**IN THE MATTER OF THE
REQUEST FOR FINAL PLAT
CONSISTING OF 61 SINGLE-
FAMILY RESIDENTIAL
BUILDING LOTS AND 16
COMMON LOTS ON 24.17 ACRES
OF LAND IN THE R-8 ZONING
DISTRICT FOR SOUTHRIDGE
SUBDIVISION NO. 2**

CASE NO. FP-2025-0011

**ORDER OF CONDITIONAL
APPROVAL OF FINAL PLAT**

SUBJECT: FP-2025-0011
Southridge South No. 2

A. Preliminary Plat (date: 12/7/2020)

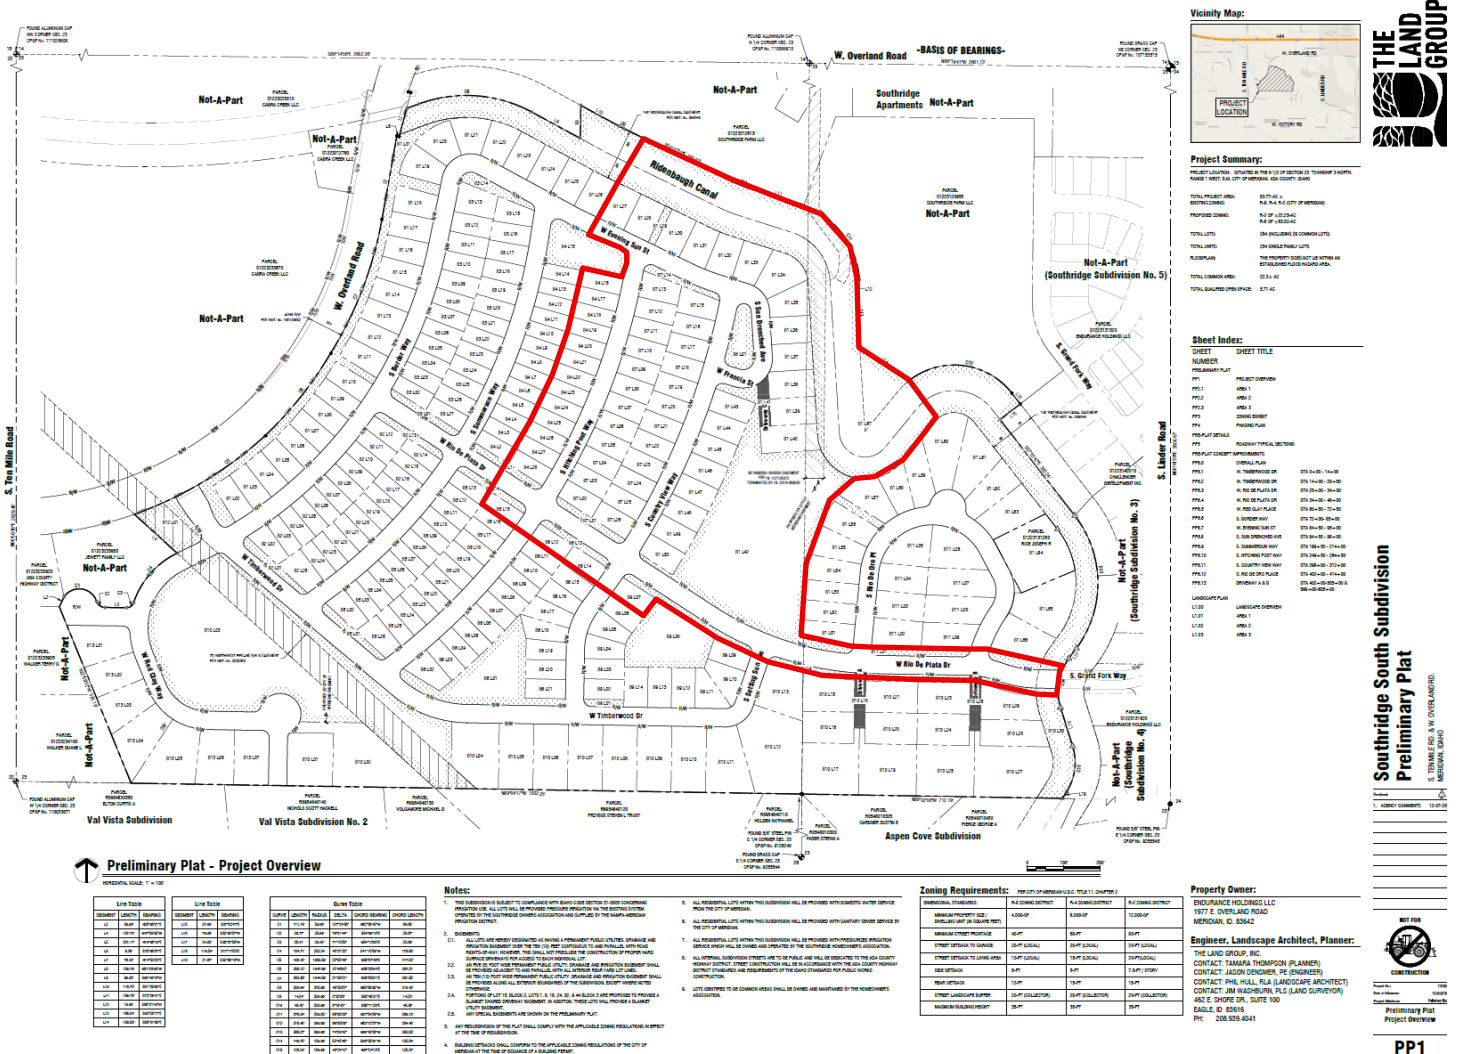
Staff has reviewed the proposed final plat for substantial compliance with the preliminary plat and associated conditions of approval as required by UDC 11-6B-3C.2. The final plat includes a minor reconfiguration of Blocks 1 and 8 from the layout approved with the preliminary plat resulting in one (1) fewer buildable lot and a slight decrease of 4,595 sq. ft. in common open space area for this phase. Because the overall development provided 208,249 sq. ft. *more* than the minimum requirement, Staff approves the reduction and finds the proposed final plat is in substantial compliance with the approved preliminary plat as required.

B. Final Plat (date: 7/28/2025)

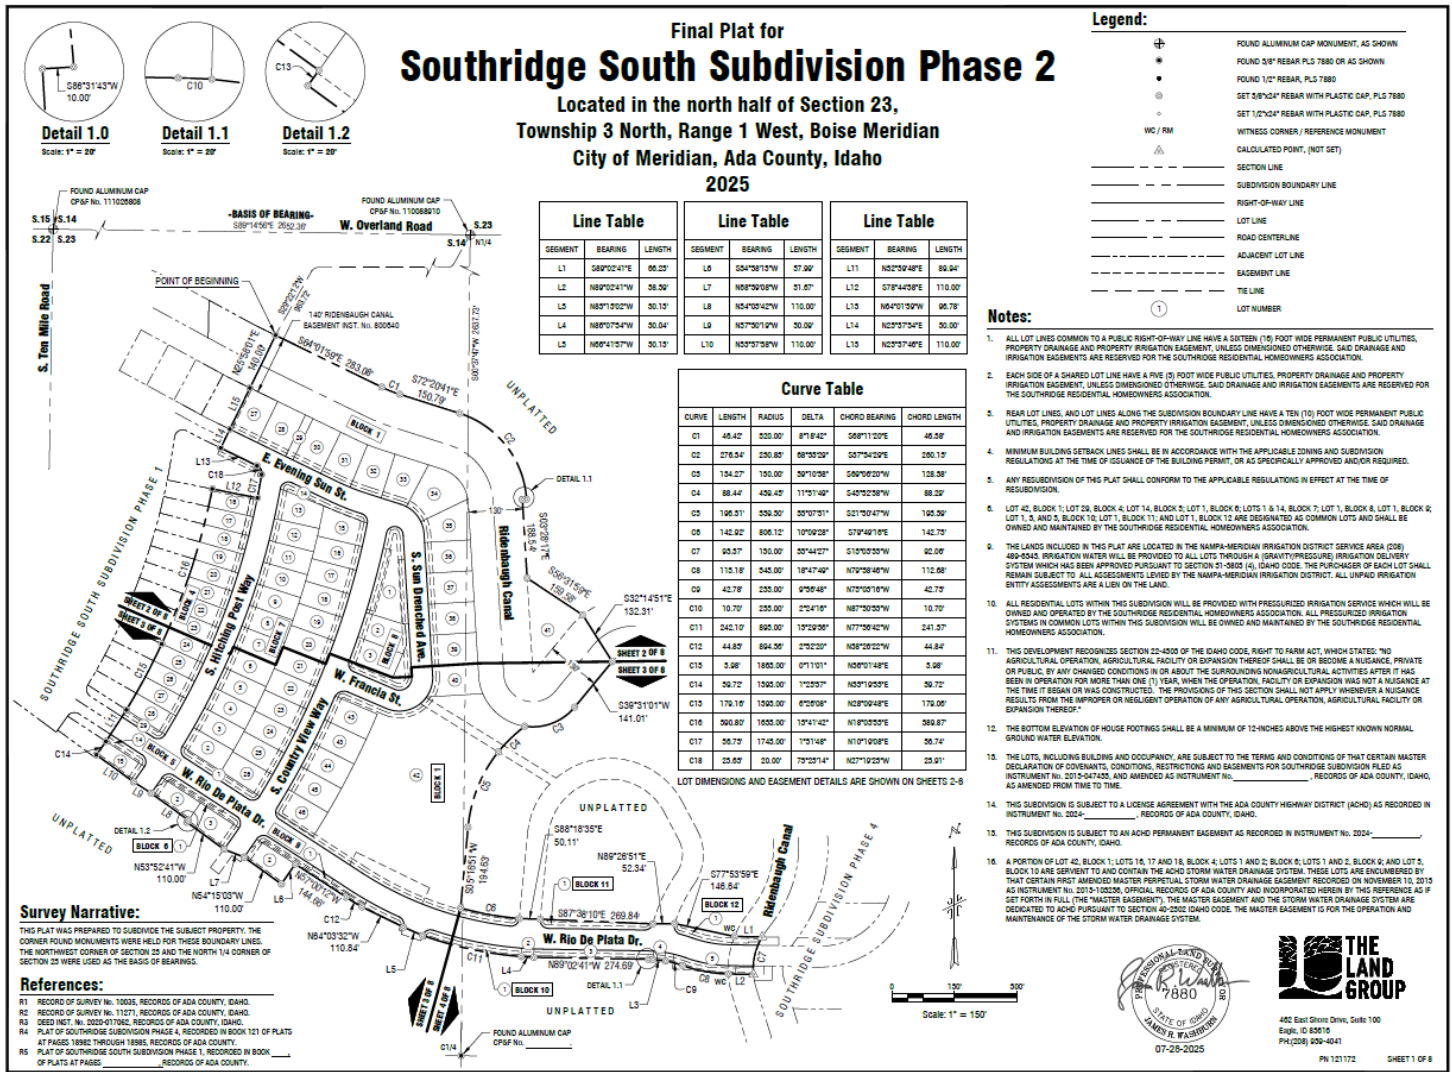
3. Prior to submittal for the City Engineer's signature, have the Certificate of Owners and the accompanying acknowledgement signed and notarized.
4. The final plat shown in Section V.B prepared by The Land Group, stamped on 7/28/2025 by James R. Washburn, shall be revised as follows:

- a. Note #13: Include the recorded instrument number of the amended CC&R's.
 - b. Note #14: Include the recorded instrument number of the license agreement with ACHD.

- c. Note #15: Include recorded instrument number of the ACHD permanent easement.
 - d. Under the References section, include the book and page number of the final plat for Southridge South Subdivision No. 1.

- e. Sheet 1: Include the CP&F No. graphically depicted on the plat.
 - f. Sheet 3: Include the recorded instrument number of the City of Meridian Public Works easements graphically depicted on the plat.

- g. Sheet 4: Include the instrument number of the ACHD storm drainage easement graphically depicted on the plat.

A copy of the revised plat shall be submitted with the final plat signature application.
